Department of Energy

FOIA #BPA-2012-01416-F

All documents related to the John Day – McNary Transmission Line Project structure 59/4 change from drilled pier foundation to grillage.

McNary - John Day No. 1 500kV Transmission Line Project

TOWER SITE DATA

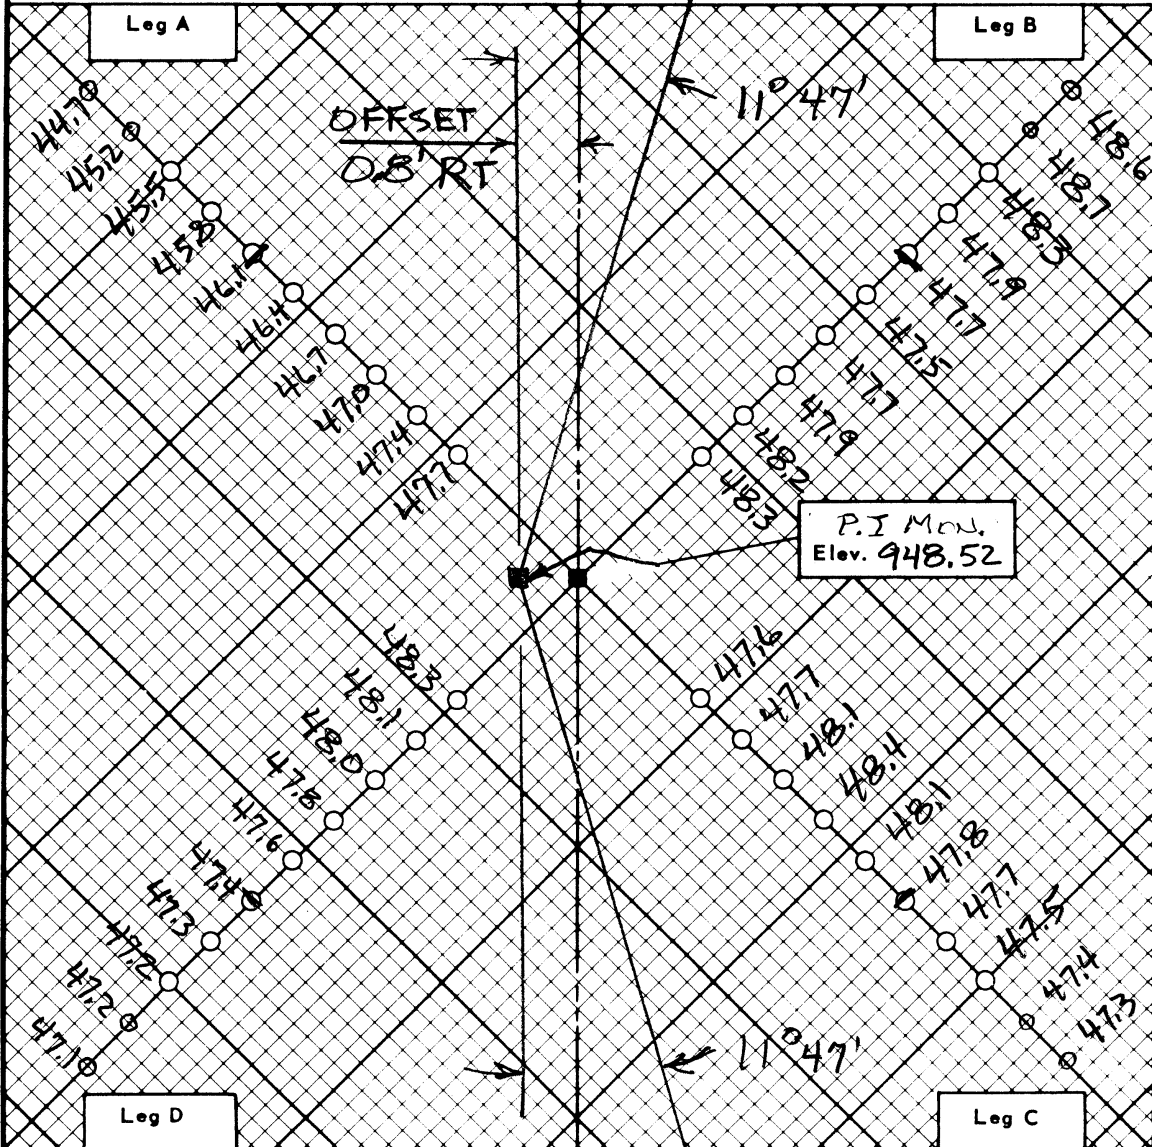
This is to confirm that all four footings at 59/4 have been changed to grillages after a site visit by our geotechnical engineer this morning. The fractured rock found at this location is not suitable for the 20 ft deep shafts that were planned for this location based on reported rock depth of 4-6 ft. (refer to photos submitted w/RFI #28) As-built the structure list to reflect this change. As discussed, use the extra Grillages already on site. Call me if you have any questions. Submit a price proposal within 4 weeks to make an equitable adjustment for this change.

1. Changed footing type from shaft to grillage based on soil conditions. 9/10/10 NDM
